Re: 779 Snodgrass Road
Crownsville, MD 21032
Tax No.: 2413-0317-1620
Case #2024-0215-V

We have received the recommendations/comments on the Variance for the above-referenced property, and on behalf of our client, Matthew Rhoderick, contract purchaser, we are submitting herewith a revised Variance application for development of the site.

VARIANCE/GRADING & SEDIMENT CONTROL PLAN

LOTS 22 & 23, BLOCK 36B, SECTION E,
HERALD HARBOR

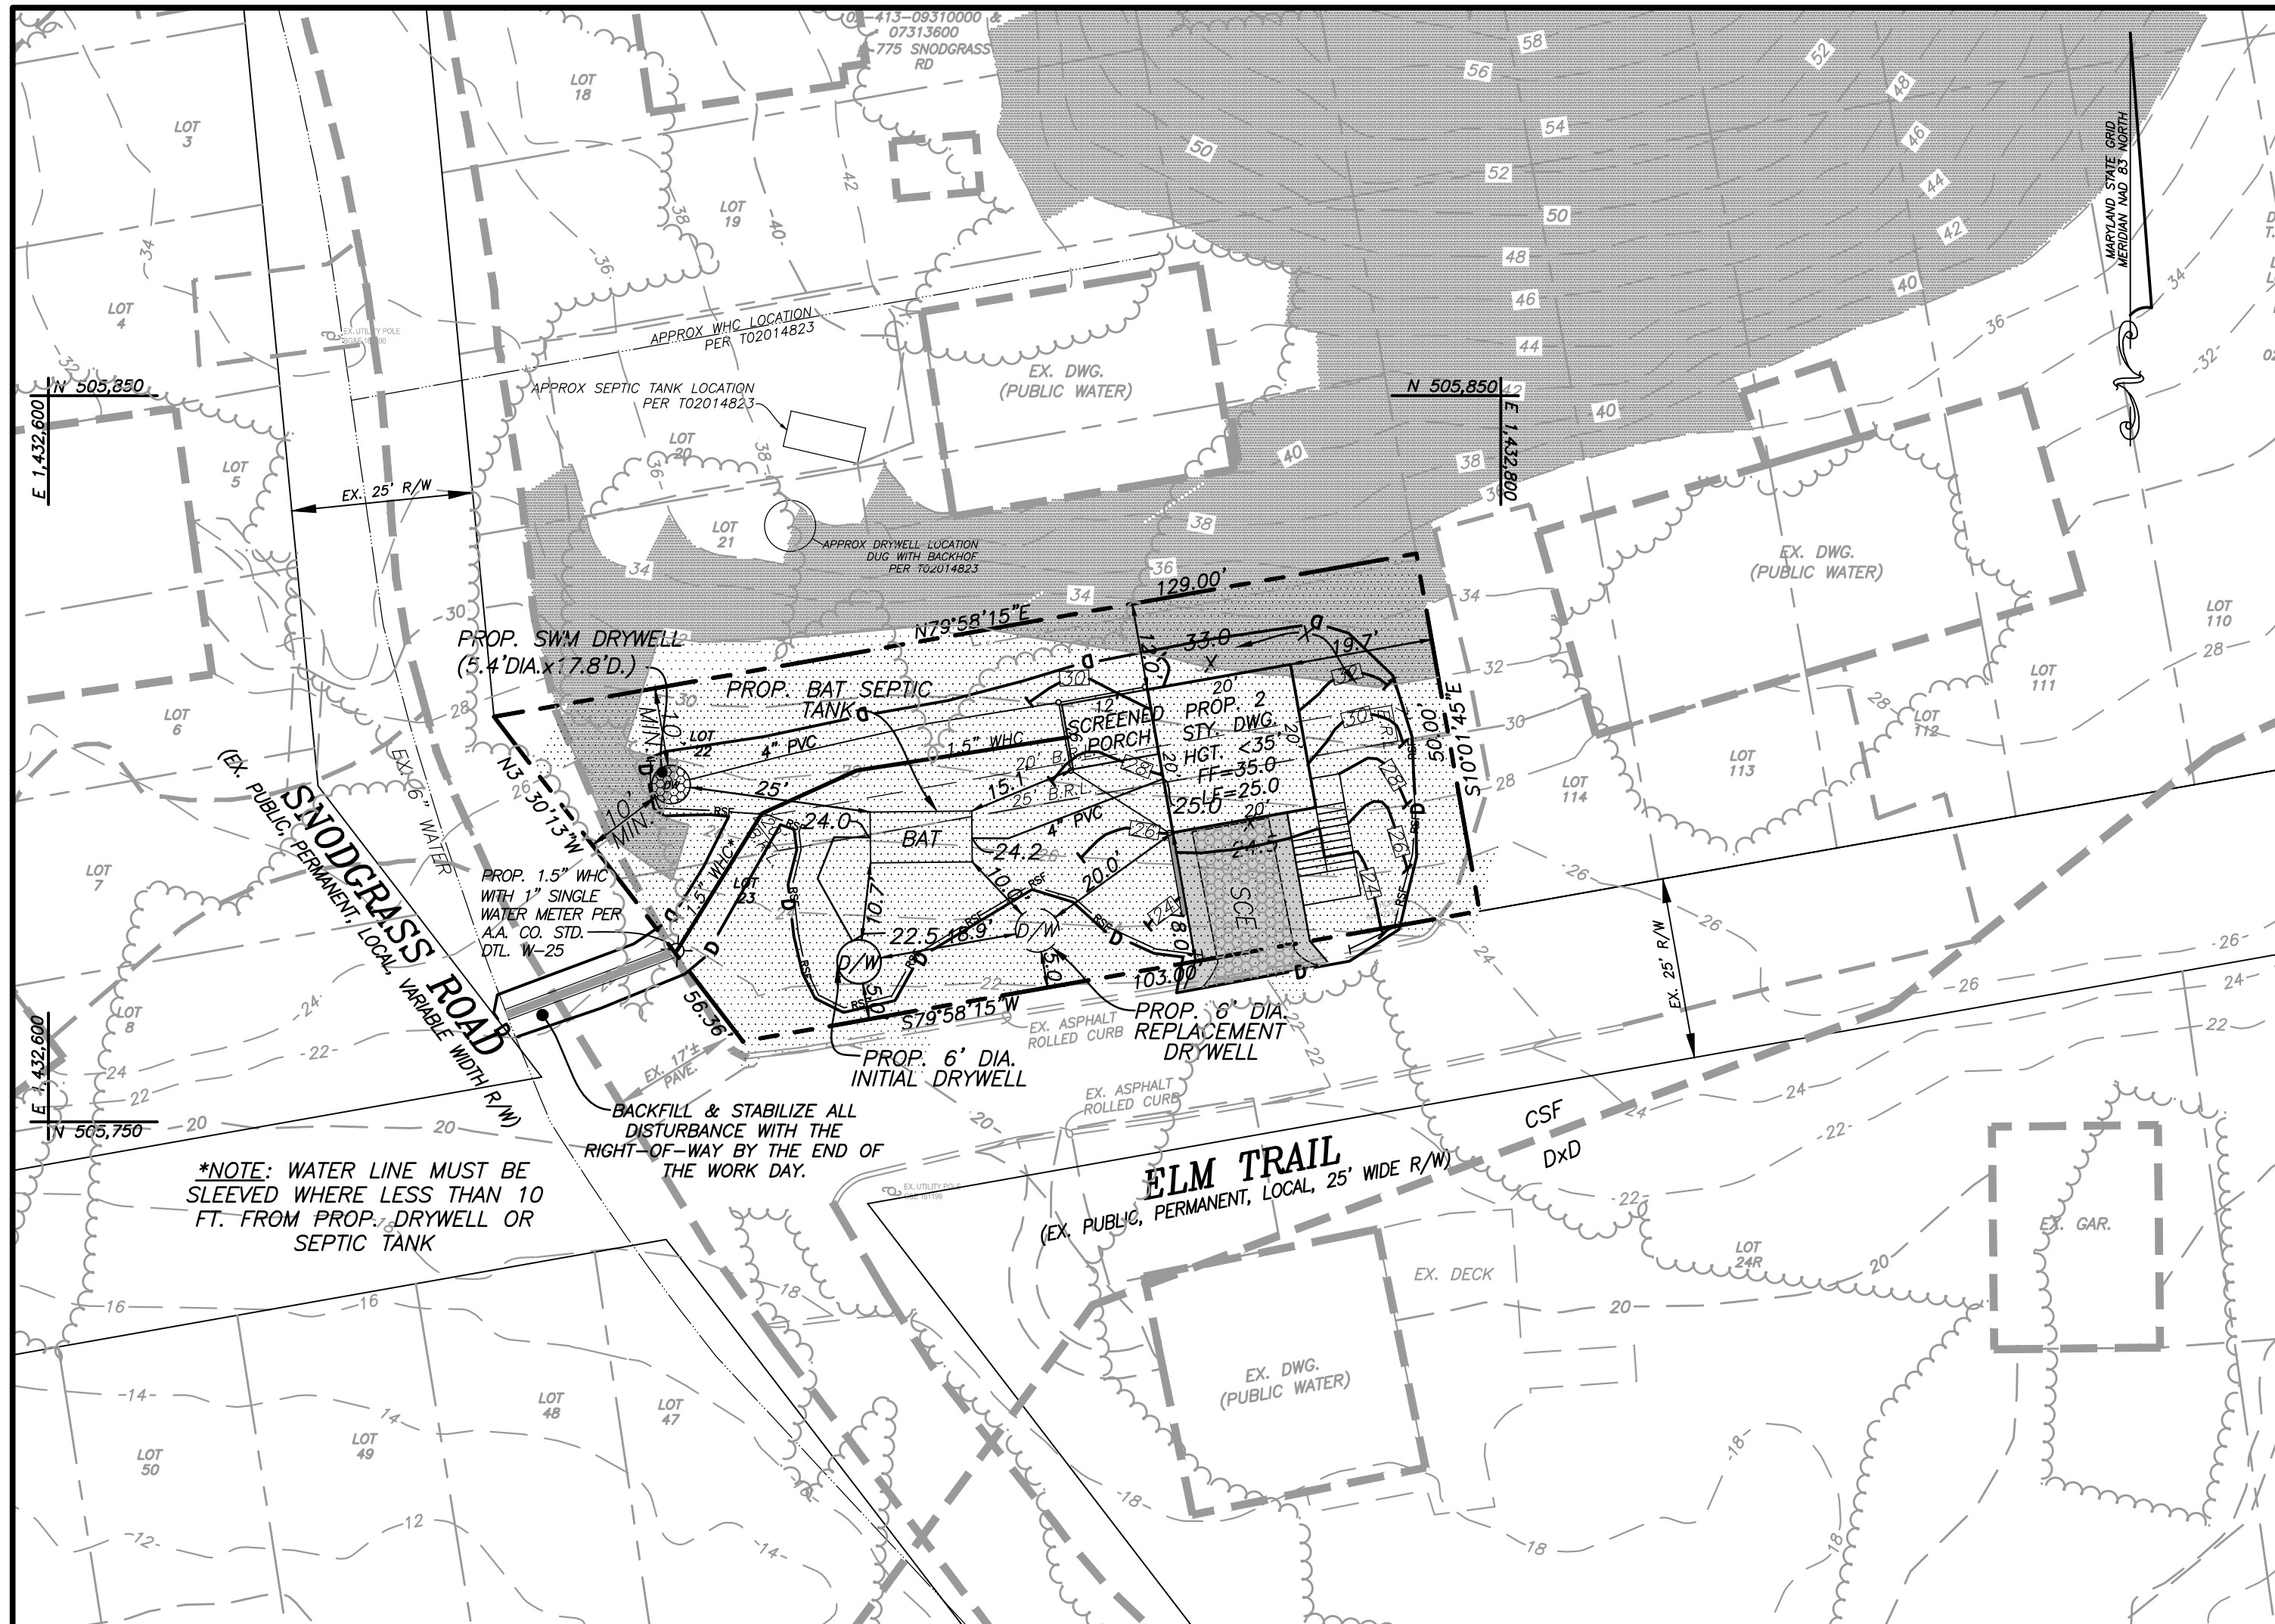
From the comments dated 12/9/24 from Jean Janvier with I&P Engineering

3. The Code reference for the zoning setbacks has been updated; however, the requested relief is unaffected.
4. The hatching for lot coverage shown on the County topo map has been thawed.

5. With the reduction in the building footprint the downspouts along the eastern side are unnecessary and have been removed from the plan.
6. The address on the Variance application has been corrected to match the Site Plan.

7. As shown on the Site Plan, asphalt curb exists on both sides of Elm Trail.
8. The linetype for the existing water line has been shown in the Legend.
9. The limits of 15%+ slope are shown on the Variance Site Plan. The Environmental Health Department does not require setbacks to 15%+ slopes; therefore, only the 25%+ slopes are reflected on the Septic Plan.

23. A list of all property owners within 300' was submitted with the Variance application; however, the plan has been revised to include a list of all abutting property owners.

24. For ease of presentation at the Variance hearing, the site plan has been reduced to one sheet. The remaining items noted in the SFD checklist not included in the Variance Plan will be provided on the grading plans submitted with the grading permit in the future.

34. The plan has been revised to label the size of the water connection and existing mains abutting the site.
35. The approved red-stamped septic plan for the new/reduced dwelling has been submitted herewith.

SEPTIC PLAN
LOTS 22 & 23 HERALD HARBOR
TAX MAP 31 BLOCK 23, PARCEL 390
ZONED R5

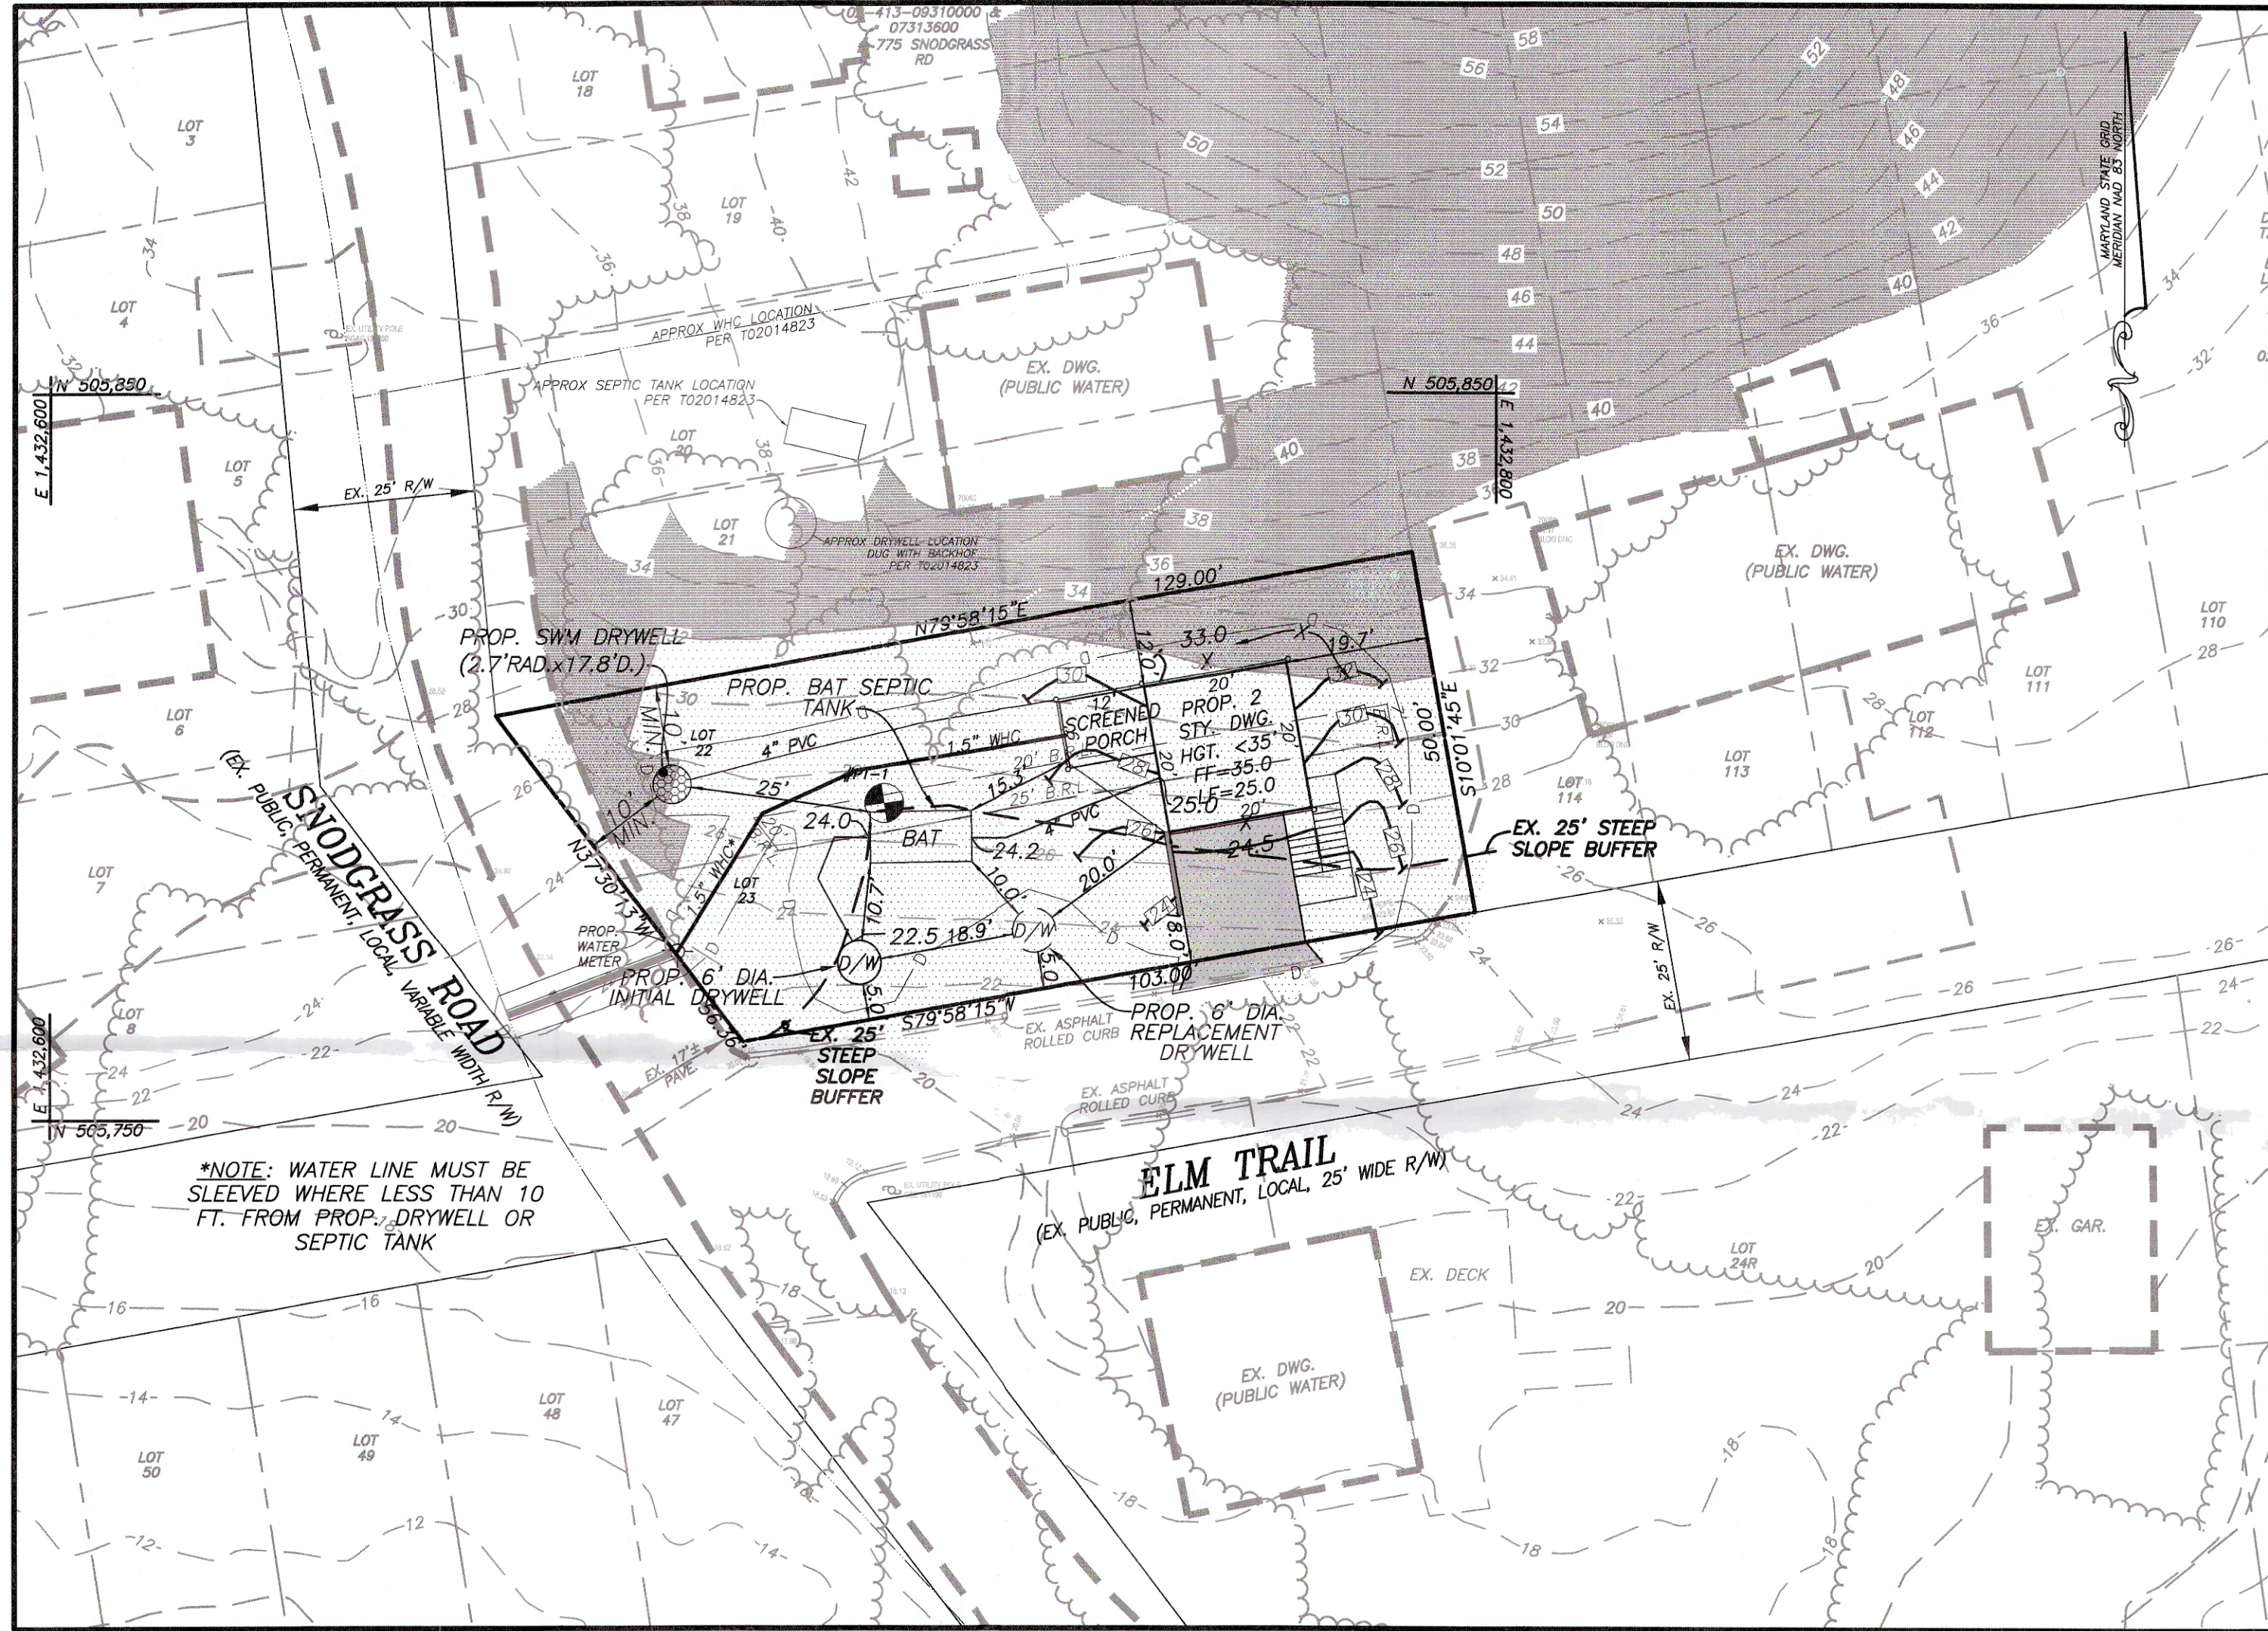
From the Memo dated 11/27/24 from Brian Chew with Environmental Health

The septic plan for the revised house and site improvements was approved on 2/4/25, as shown by the red-stamp septic plan submitted herewith.

13. The year of the SCS specifications has been updated to 2011.
14. The septic plan has been revised to reflect the reduced dwelling size and lot coverage.

NO.	DATE	BY	REVISION	APPROVED	DATE
2-3-25	JET		REVISE PLAN TO SHOW NEW HOUSE FOOTPRINT. NO CHANGES TO PREVIOUSLY APPROVED SEPTIC.
